## COUNCIL ASSESSMENT PANEL MEETING

### AGENDA – 9.1

<b>Applicant:</b> GE Hughes Construction Co	<b>Landowner:</b> Hughes Properties Pty Ltd
<b>Agent:</b> Peter Meline	<b>Originating Officer:</b> Melanie Scott
<b>Development Application:</b>	19/532/473
<b>Application Description:</b> Variation to Development Authorisation 19/532/473 to vary truck wash location, combined fence and retaining wall height (maximum 4.4m), retaining walls height (maximum height 2m) and retaining wall location and associated earthworks  Original Proposal: Change of use to include a transport depot and extend an existing vehicle hardstand, retaining walls, combined fence and retaining (maximum height 4.15 metres), 2 x 28000 litre fuel storage pods, storage building, outbuilding for truck wash equipment, 2 x 20000 litre water tanks & associated earthworks	
<b>Subject Land:</b> Lot:3 Sec: P5140 FP:125204 CT: 5220/438	<b>General Location:</b> 4 Brettig Road Lobethal  <b>Attachment – Locality Plan</b>

The purpose of this report is to seek the Consent of the Council Assessment Panel (CAP) for further variation number 2 to Development Authorisation 19/532/473, determined by CAP on 9 June 2021. The original pr

**SITE PLAN**

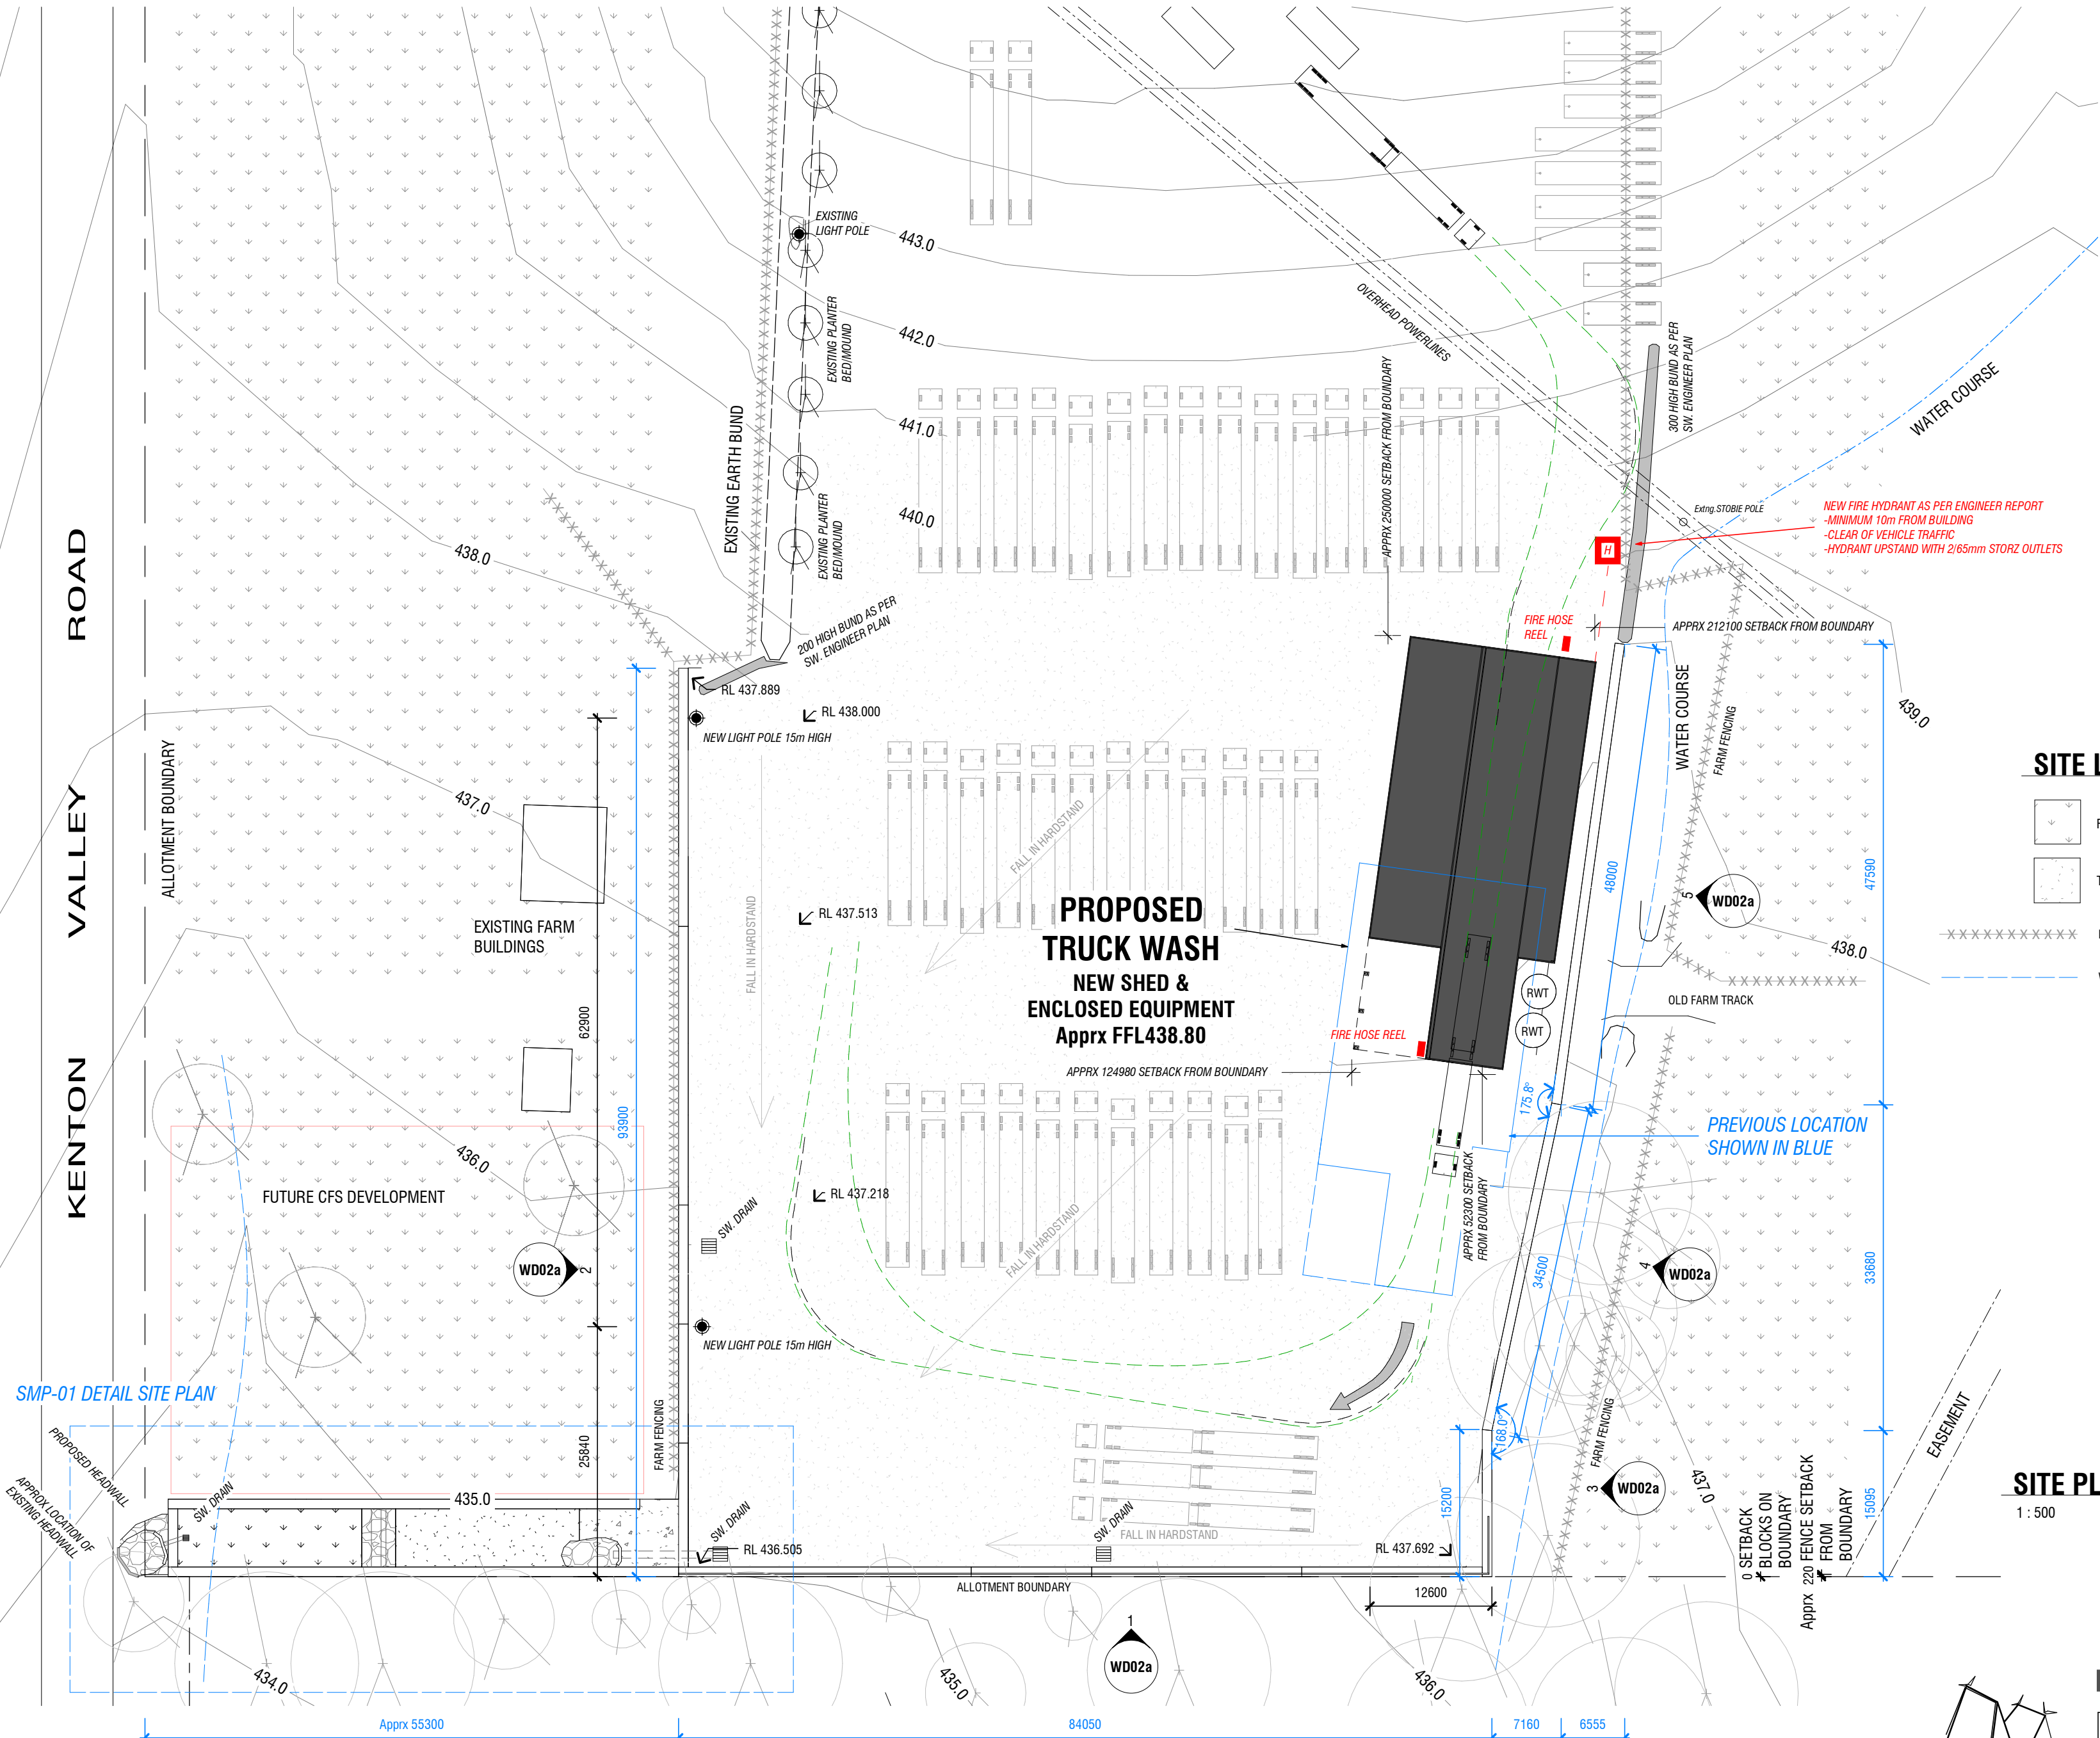
- the combined fence and retaining wall on the southern boundary was approved at 4.15 metres high and the proposed new height is at 4.4metres (.25metre higher)
- new retaining wall returns on the eastern and western edges of the hardstand which vary in height from being buried to 1.7m where they connect to the southern boundary retaining wall. These new retaining walls are internal to the site.
- The truck wash building has been relocated further north on the site, now proposed at approximately 52 metres from the southern boundary (was originally approved at 36 metres then varied to 29 metres) which has seen the FFL increase by .8 metre from 438 to 438.8 as the hardstand does slope up hill to the north.

- BIO RETENTION DETAILS AMENDED (AS PER RESERVED MATTER)
- NEW BLOCK RETAINING WALL  
Western side of Truck Hardstand
- NEW BLOCK RETAINING WALL  
Eastern side of Truck Hardstand
- MINOR DETAIL CHANGES TO BOUNDARY WALL  
Southern conc. block retaining wall and fence.  
Onsite 'as-built' variation to embedment depth
- ADDITIONAL RETURN CORNER TO COLORBOND FENCE
- VARIATION TO SHED LOCATION & RESULTING CHANGE IN FLOOR LEVEL  
Improved truck entry and exit  
Increased distance from Southern neighbour  
Floor level adjusted to suit adjacent topography levels
- ENCLOSURE OF 'STORAGE VERANDAH' in the Utility side of Truckwash Shed
- ADJUSTMENT TO PA. EXIT DOOR LOCATIONS

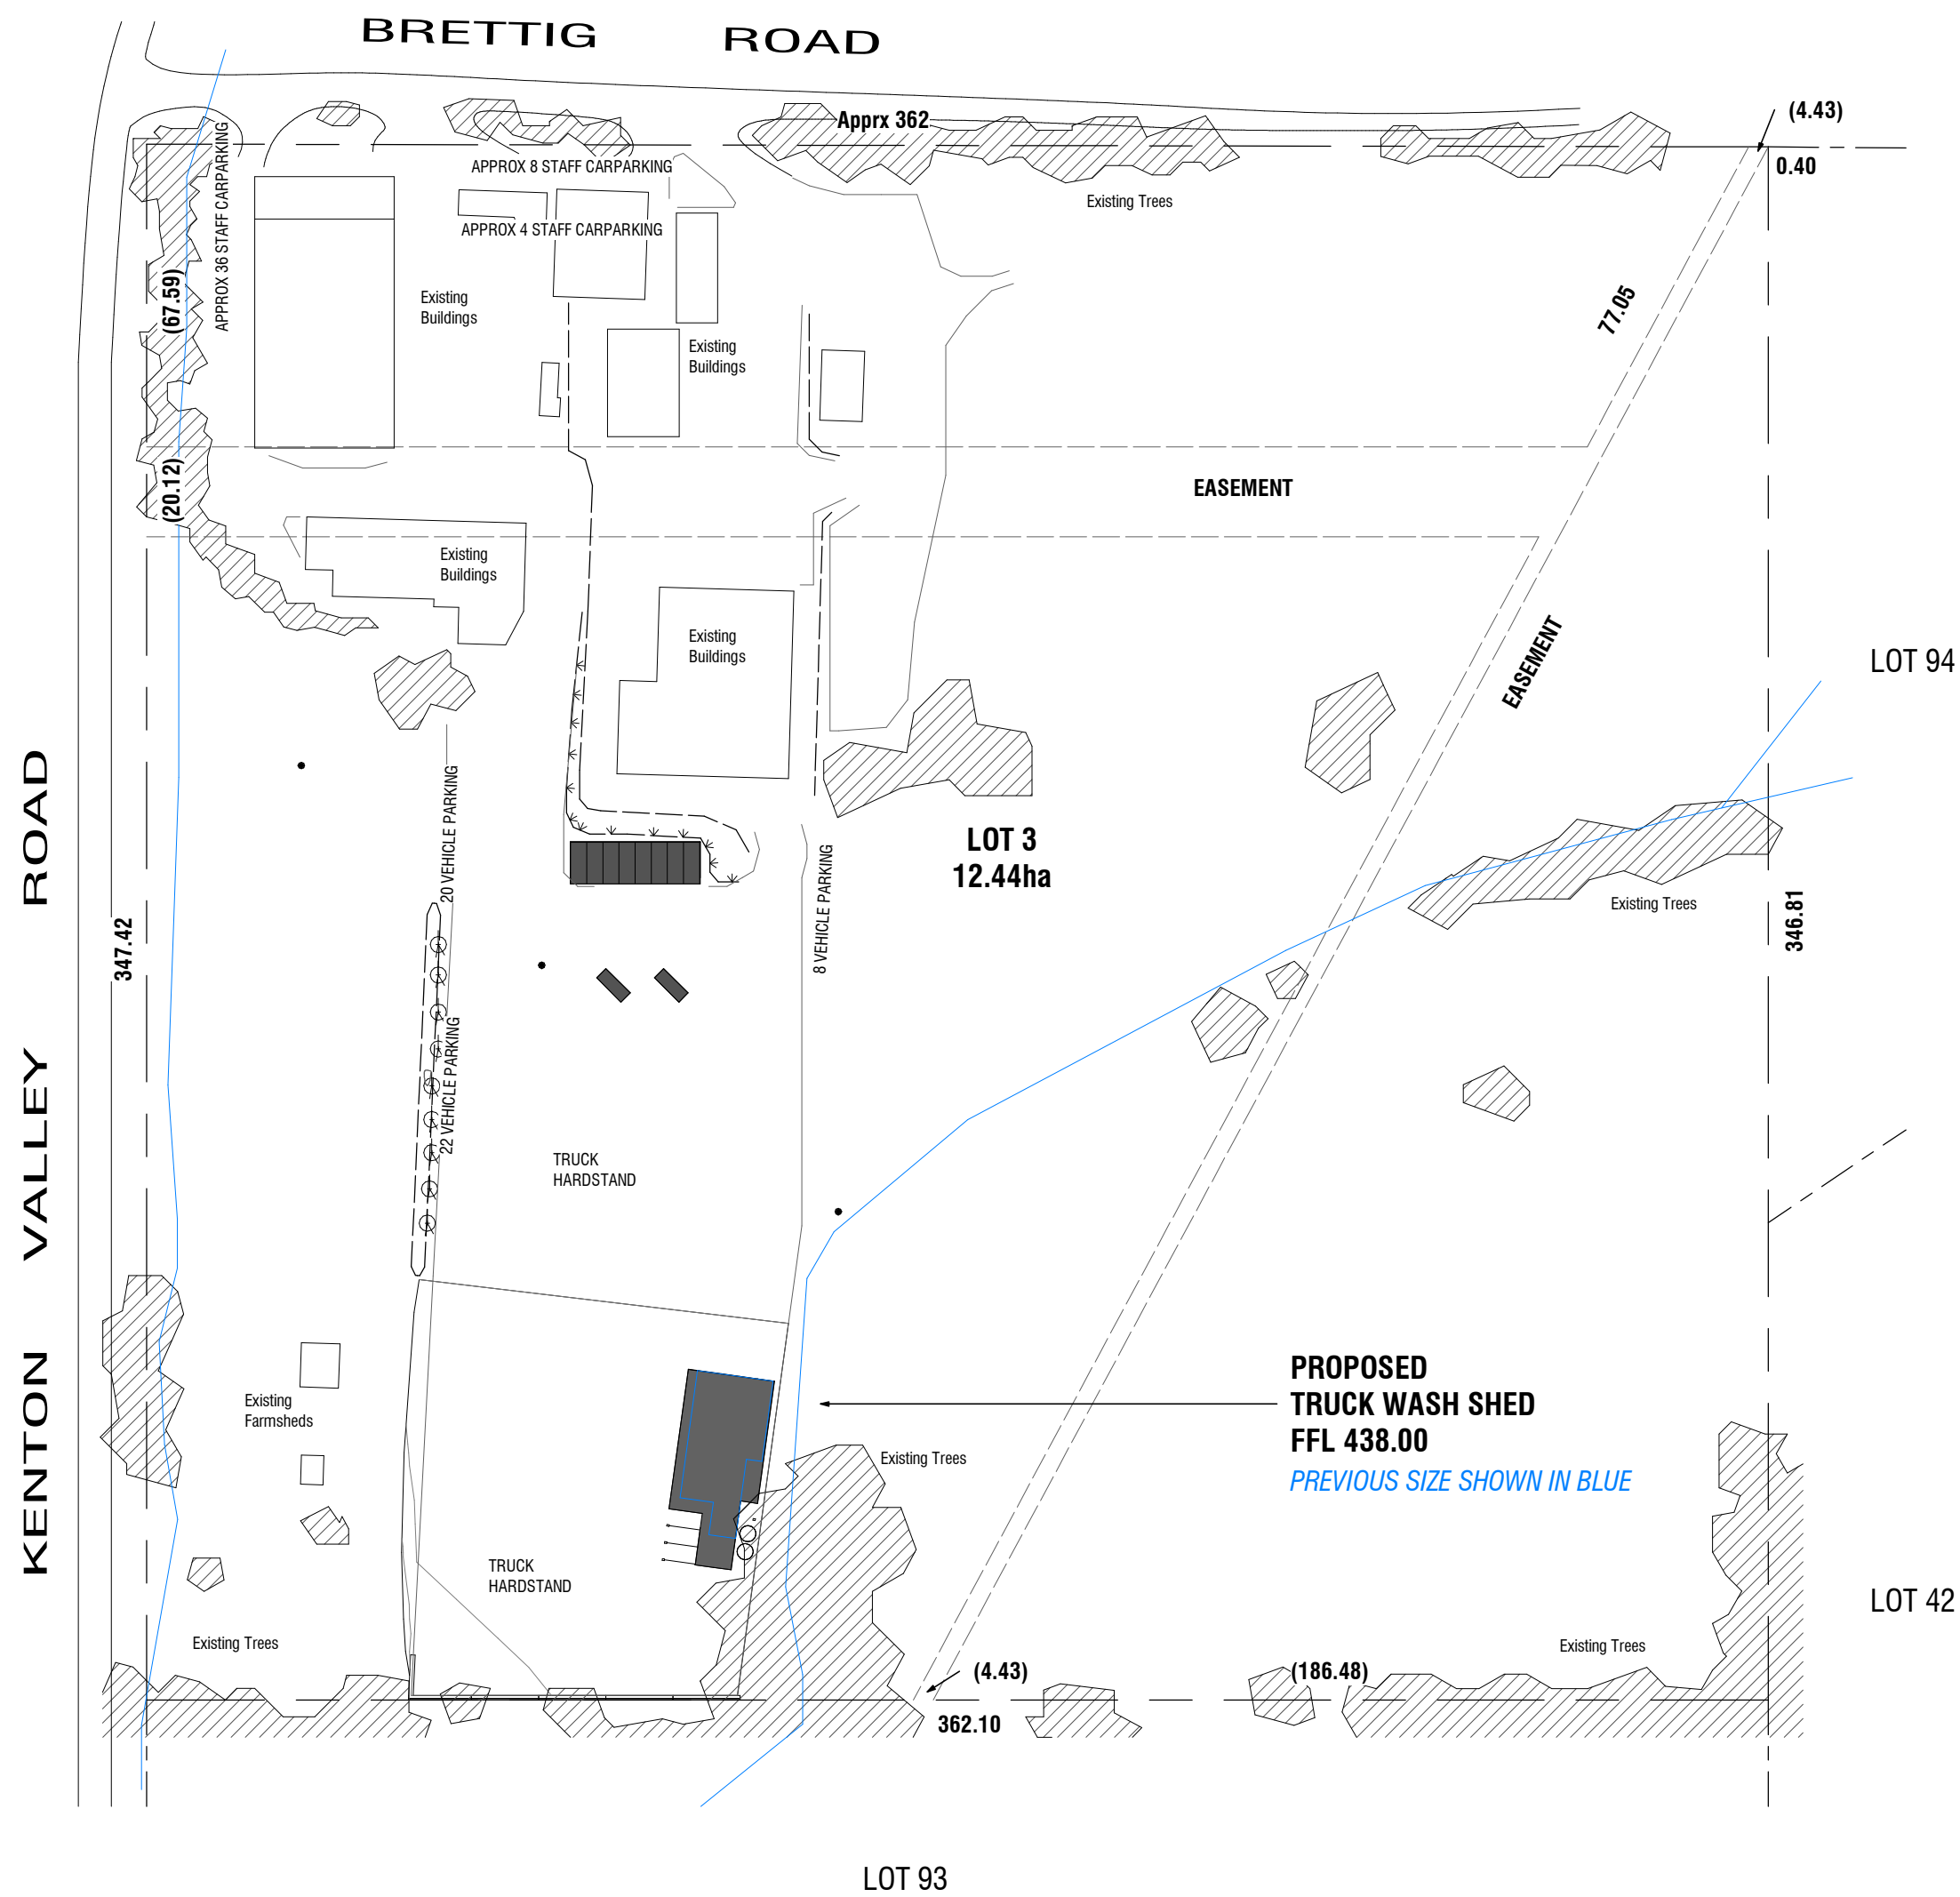
The approved plan had the building set back approximately 39metres from the southern boundary. The proposed building is set back approximately 29metres from the southern boundary. Given the turning circle can still be accommodated the proposed fencing on the boundary is unaltered I am of the opinion the new location will have minimal impact and not an unreasonable impact on the neighbouring property despite being 10 metres closer.

The CAP approved footprint was 548m<sup>2</sup>. The amended proposal has a footprint of 710m<sup>2</sup>, an increase of 162m<sup>2</sup> or a 30% increase. In my opinion as the proposed variation to the building is only one element of the application and does not change the number of trucks

The length of the building changes from 36m to 43m. The main truck wash portion increases in width from 6m to 8m and there is a .3m increase in the utility room from 3.5m to 3.8m. The machinery storage area remains at 7.5m width with an increased length.

In my opinion as the proposed variation to the building is only one element of the application and does not change the number of trucks (50 per condition 7) or the hours of operation of the proposed truck wash (condition 6) the application is not changed substantively and the impact on neighbours is not considered unreasonable the variation is considered minor.
